SUBJECT: 4700, 4800 Output Shaft – Rear Cover and Retarder Rear Modules

MODELS AFFECTED: 4000 Series™ - All 4700, 4800 models

Figure 1. Output Shaft Assembly Identification

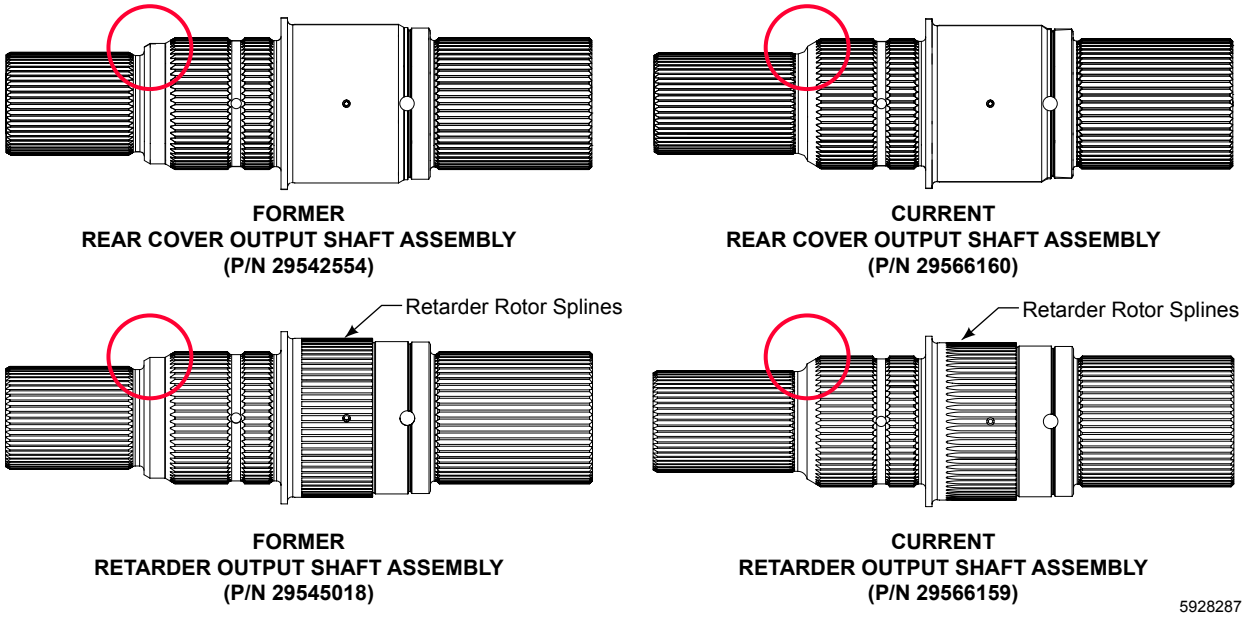
As a continuous product improvement, a change has been been made to the 4000 Series™ 4700/4800 7-speed Output Shaft for both Rear Cover and Retarder modules. Current part numbers (P/N) are mandatory for the forthcoming 4900 and 4970 models and optional for all other 4700 and 4800 based models. Due to the nature of the change and full backward compatibility of the current part numbers, individual serial number (S/N) breakpoints were not established and are unnecessary. For information regarding part identification see Figure 1.

NOTE: Note geometry changes to shoulder (circled) between Former (Left) and Current (Right) configurations.

Note addition of spline to OD of shaft for Retarder models (Bottom).
